**CITY OF PEABODY, MASSACHUSETTS**

**WEST PEABODY PUMP STATION, DWSRF No. 4592**

**WEST PEABODY PUMP STATION, DWSRF No. 4592**  
**ADDENDUM No. 1**

**C101**

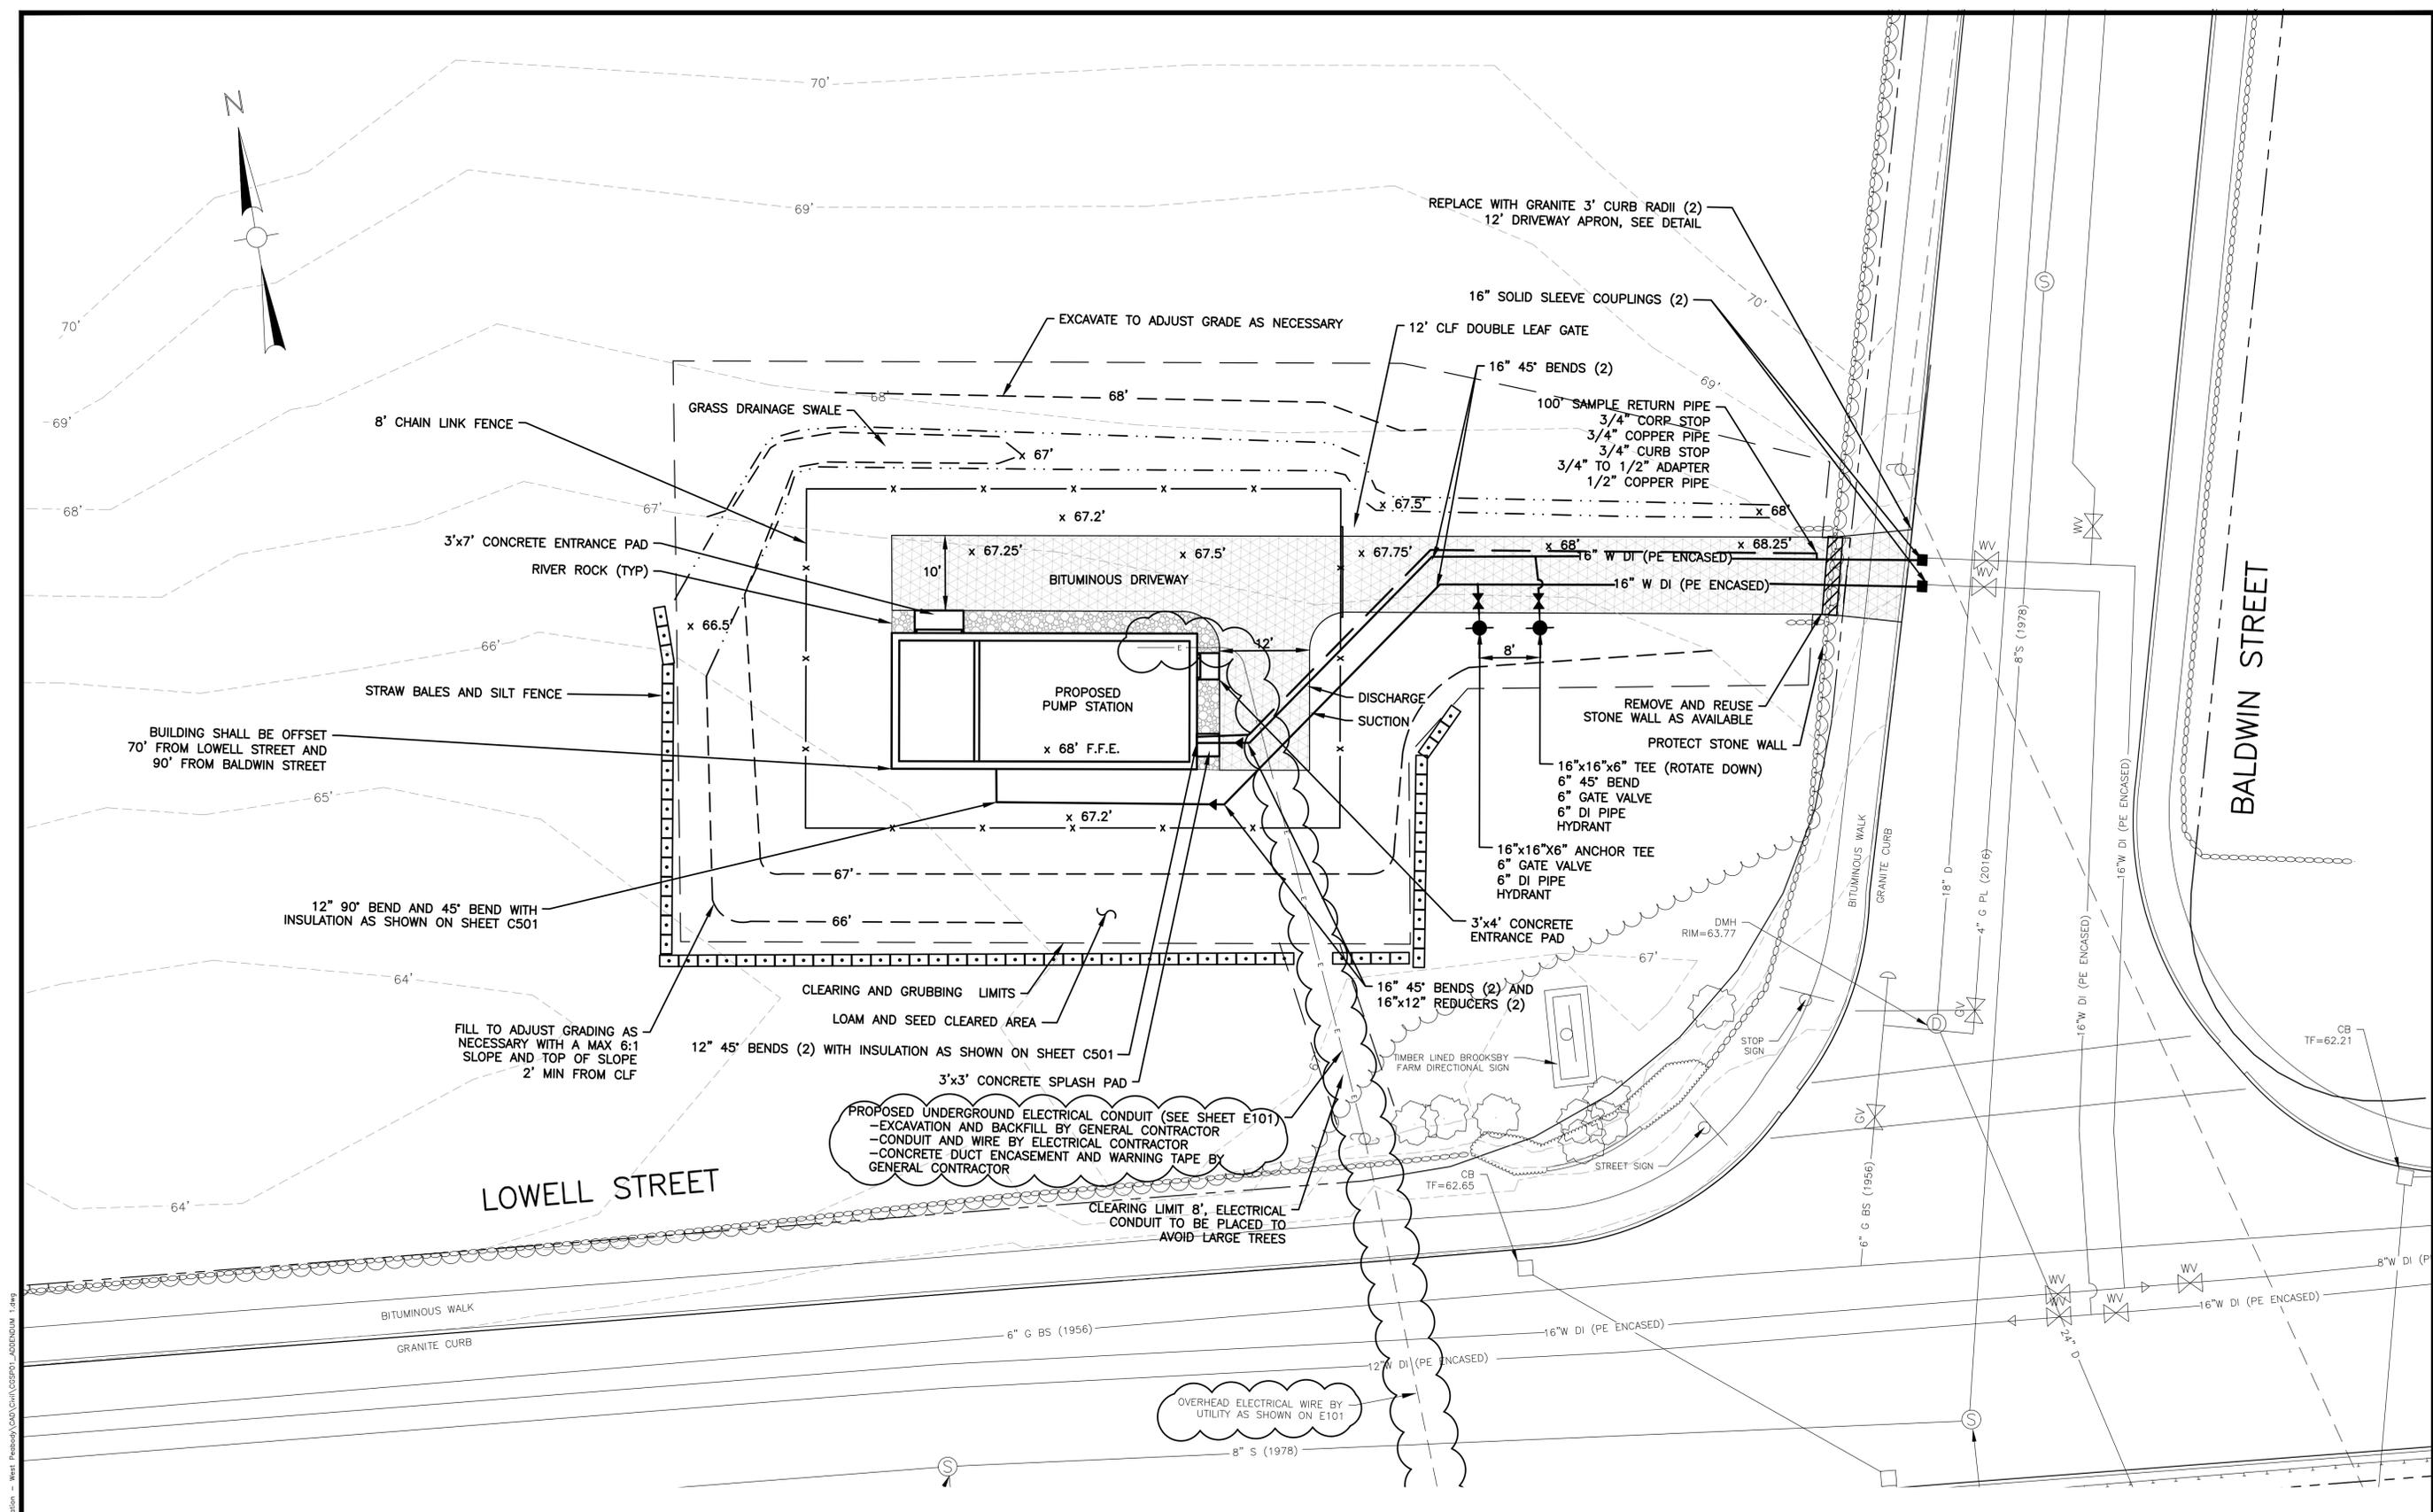
See attached new sketch C101.
